## MEMORANDUM

### BROMYARD FORWARD PLANNING - LANDSCAPE RESPONSE

**SITE:** BROMYARD

**PROPOSAL:** NORTHERN RESIDENTIAL EXTENSION AND LINTON EMPLOYMENT SITE

Plan 1: Initial residential extension proposals (October 2010)

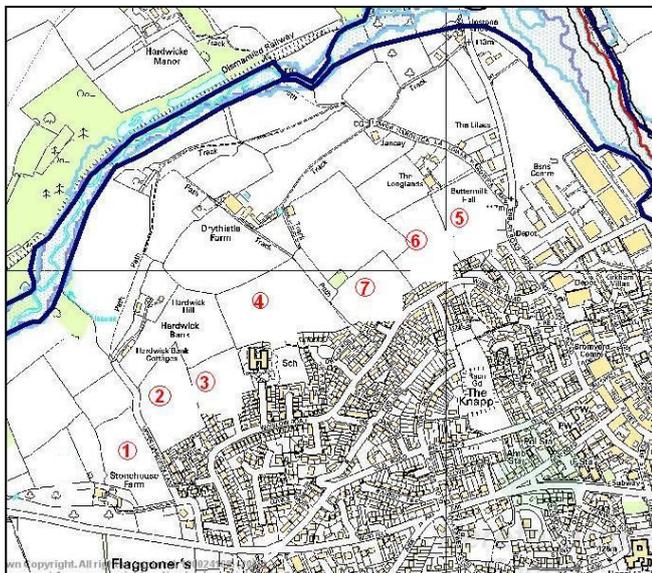
The land being considered for future housing in the Core Strategy is located on the northern edge of Bromyard. This is an area of high ground, which slopes steeply to the north and west, down to the valley of the River Frome. The fields marked number 2 and 3 opposite are some of the highest points in Bromyard, at 170m. These fields all fall within the Character Area of Timbered Plateau Farmlands. The adjoining residential area is defined as Urban character.

The dominant landform is one of the most prominent characteristics and tends to override the patterns of tree cover and field shape. The topography in this area contributes to three more localised character areas:- the west facing slopes of fields 2,3 and 4; the east facing slopes of field 5, 6 and 7; and the lower corridor of the river itself. **Any housing development should therefore respect and work with the existing slopes and local character.**

Fields 2 and 3 are the most enclosed, with areas of level ground that could be suitable for development. They are currently defined as High-medium sensitivity. These fields already have some visual relationship with existing built development, being at a similar elevation. Development on field 4 has difficulties of access and integration with the existing town and will have a large landscape impact.

Upper Hardwick Lane currently marks a definite western edge to the settlement. Development on field 1, with access from the A44, will extend the urban area beyond this and it will be hard to integrate with the existing town due to the rural nature of the lane.

A new access road from the Tenbury Road would be partly screened from distant views by the industrial estate opposite and seen in context with the existing housing, which is a clearly visible sharp edge in the landscape. Residential development on the lower fields (5 and 6) has been ruled out during the preferred options consultation – therefore an access road at this location would be divorced from the existing town and the new development; a scar on the landscape that is not linked to the urban area.

Plan 2: Alternative extension proposals for residential and employment combined (August 2012)

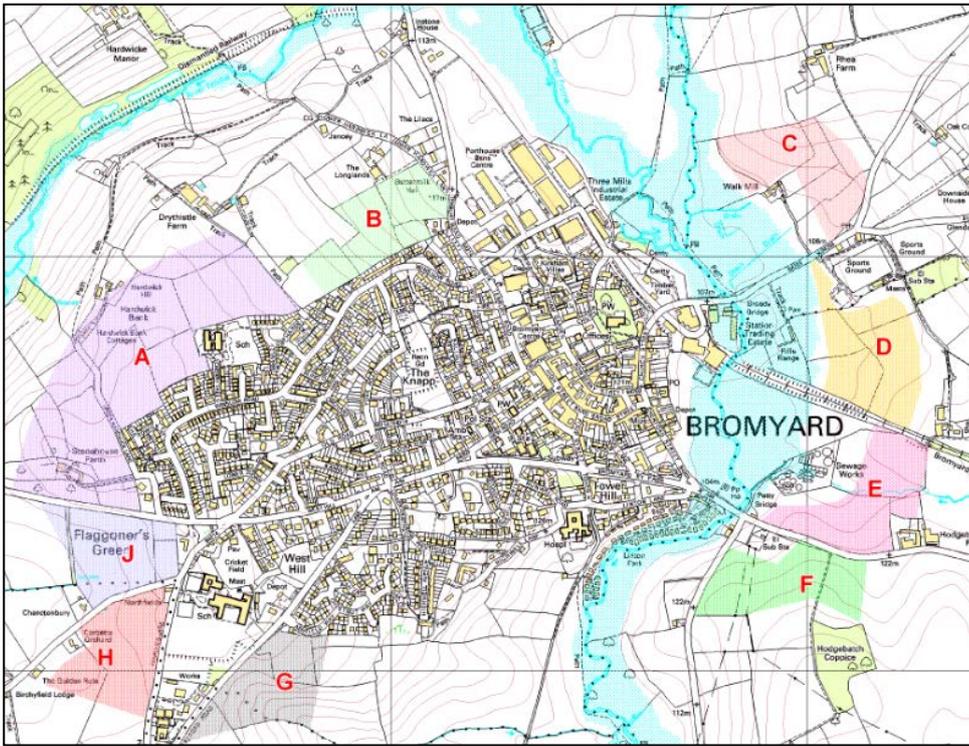
Previously put forward and assessed as above (fields marked 1 -4). Fields 2 and 3 are considered suitable for housing development, provided they could be accessed from the existing residential development. Field 1 is visually prominent on the edge of the town and any development here would significantly alter the landscape character of Stonehouse Farm. Any new road access from the A44 to the north would have a negative impact on Upper Hardwick Lane (as previously stated). Field 4, to the north of the primary school was assessed in more detail, particularly in views from Bromyard Downs. Development on this field would be visible from the Bromyard Downs and this is considered to be a negative landscape impact, given the existing form of the town and the landscape sensitivity of the Bromyard Downs.

Previously assessed as above (fields marked 5, 6 and 7). These are steeply sloping and east facing. Any development would be visible from the Bromyard Downs and would require significant ground engineering. Development on these fields would have a significant negative impact.

These sites are all to the east of the town, separated by the floodplain of the River Frome. It is this physical and visual distance from the existing built development and infrastructure that makes them unsuitable for development in landscape terms. None of these sites would be viewed as an extension of the town, more an isolated development in open countryside with little relationship to any existing infrastructure or suitable integration with the rural setting.

This is a steeply sloping, east facing field. It forms part of the River Frome valley side. Any development on this site would require significant ground engineering and would be visually intrusive. It would not integrate well with the existing development, which currently has strong tree cover around the small fields adjacent to the housing.

These sites are not closely integrated with the town centre, however H is adjacent to existing industrial, business and educational land uses between Panniers Lane and Hereford Road. The northern boundary of J is highly degraded by the large, busy infrastructure of the A44. Much of site H is relatively flat. Site J slopes from east down to the west and a buffer zone would be required to protect the existing residential development. Both sites are open to long distance views to the west, however there is not the same landscape value in this direction (compared to the Bromyard Downs to the east). Large scale agricultural buildings at Birchyfield, adjacent to H, are already visible in views towards the town from the west.
